# Samad Sweater Limited

Kalmeshwar (Battala Road) Board Bazar, Gazipur  
(23.945658, 90.385032)

07<sup>th</sup> May 2017

# Observations

# Punching shear stress levels in flat slabs

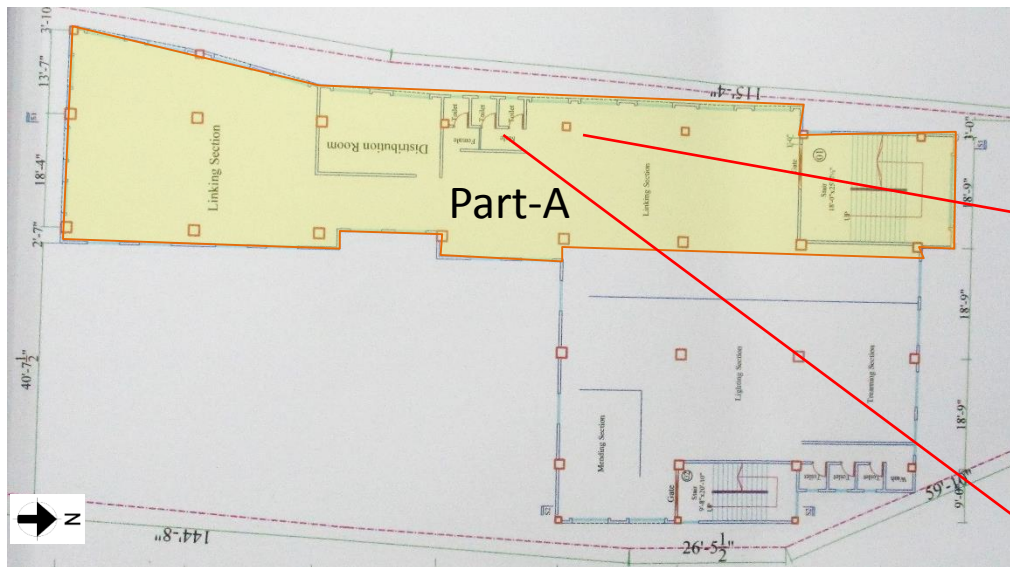
Cursory calculations indicate that punching shear stresses in flat slab floors at corner columns around toilets and at internal columns are in excess of normal design limits.

| Item No. | Observation                                                          | Recommended Action Plan                                                                                                                        | Recommended Timeline   |
|----------|----------------------------------------------------------------------|------------------------------------------------------------------------------------------------------------------------------------------------|------------------------|
| 1        | (Production Building)<br>Punching shear stress levels in flat slabs. | Factory Engineer to review design, loads and punching shear stresses in all slabs at internal columns and in toilet areas.                     | <b>Immediate - Now</b> |
| 2        | (Production Building)<br>Punching shear stress levels in flat slabs. | Verify insitu concrete strength by taking 100mm diameter cores from a minimum of 4 non-critical locations in slabs.                            | <b>Immediate - Now</b> |
| 3        | (Production Building)<br>Punching shear stress levels in flat slabs. | A Detail Engineering Assessment of Factory to be commenced, see attached Scope.                                                                | <b>Immediate - Now</b> |
| 4        | (Production Building)<br>Punching shear stress levels in flat slabs. | Make structural alterations as advised by Factory Engineer.                                                                                    | <b>6-weeks</b>         |
| 5        | (Production Building)<br>Punching shear stress levels in flat slabs. | Produce and actively manage a loading plan for all floor plates within the factory, giving consideration to slab capacity and column capacity. | <b>6-weeks</b>         |

Beam Layout

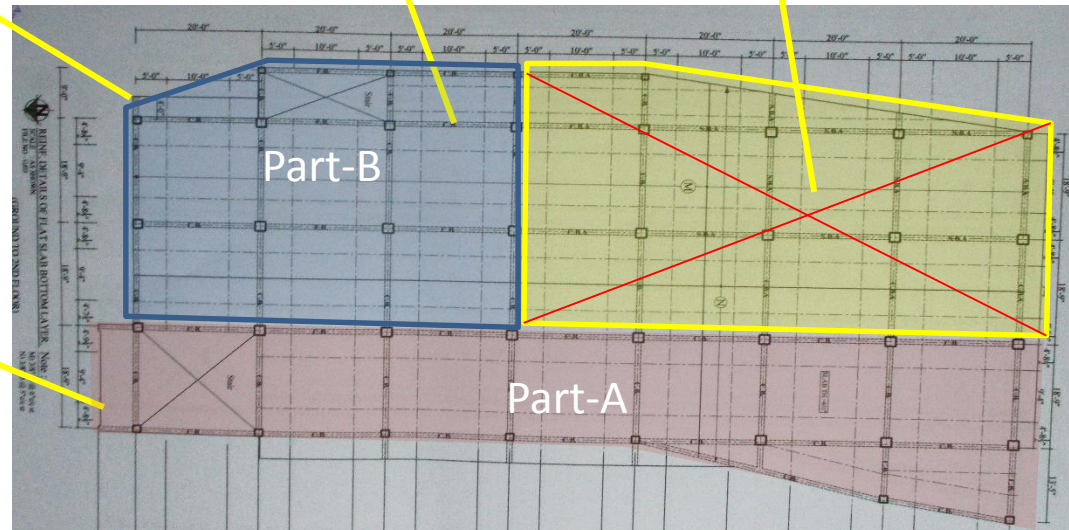
In beam layout of Part-B conceal beam was shown but 10" x 20" size beam found. All floor beams are shown as conceal beam in drawings. Also in Part-A cantilever beams were not found in stair and north side toilet which were shown in beam layout.

| Item No. | Observation                                                                       | Recommended Action Plan                                                                                                                      | Recommended Timeline |
|----------|-----------------------------------------------------------------------------------|----------------------------------------------------------------------------------------------------------------------------------------------|----------------------|
| 8        | (Production Building)<br>Mismatch in beam layout                                  | Building Engineer is required to survey the as-built structure and prepare the accurate as-built structural drawings.                        | 6-weeks              |

Column Layout Plan

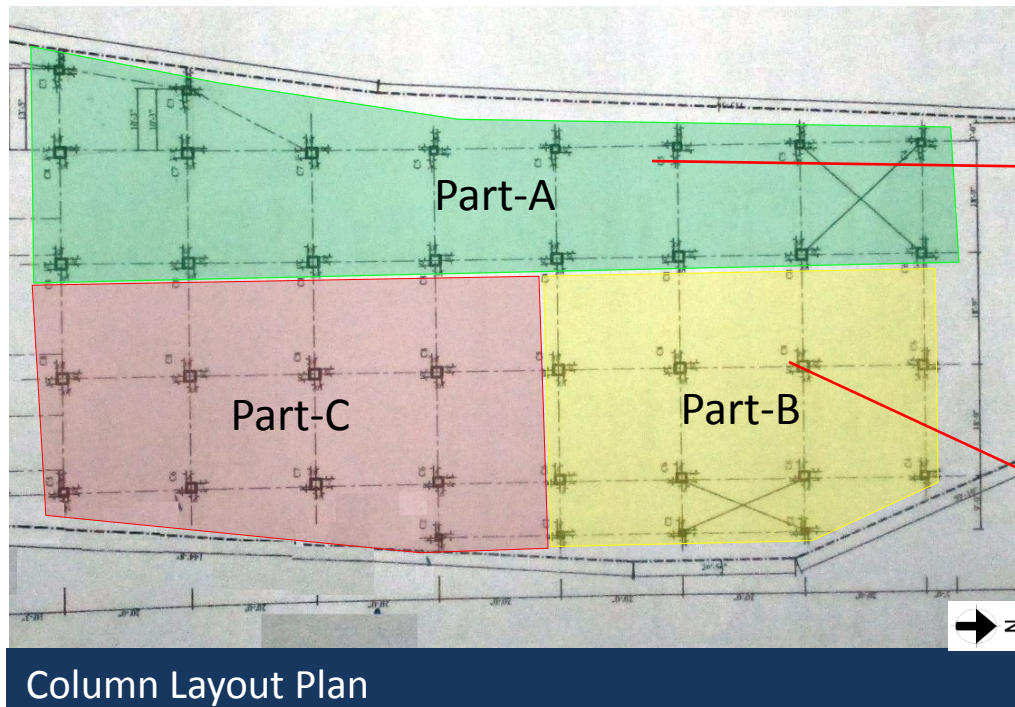
Concerns on the stability system for lateral loading and seismic loading. Flat slab system lack of lateral load resistance.

| Item No. | Observation                                                                       | Recommended Action Plan                                                                                                                      | Recommended Timeline |
|----------|-----------------------------------------------------------------------------------|----------------------------------------------------------------------------------------------------------------------------------------------|----------------------|
| 9        | (Production Building)<br>Overall stability system                                 | Carry out a Detail Engineering Assessment on the buildings to verify that they are stable under lateral loading.                             | 6-weeks              |

Ground floor layout plan (Loading/unloading area)

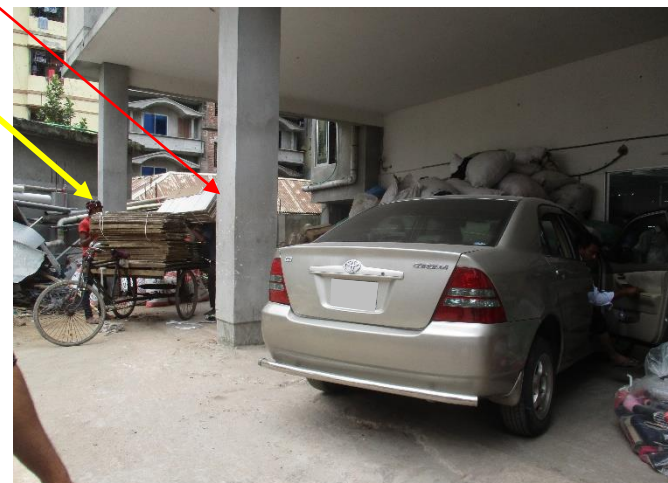
Impact protection not provided to columns at loading – unloading area. Columns were suspected to have impact loading from vehicles.

| Item No. | Observation                                                            | Recommended Action Plan                                                                                                 | Recommended Timeline |
|----------|------------------------------------------------------------------------|-------------------------------------------------------------------------------------------------------------------------|----------------------|
| 15       | (Production Building)<br>Columns suspected to vehicle impact           | Install a barrier to prevent vehicle impact in column.                                                                  | 6-weeks              |
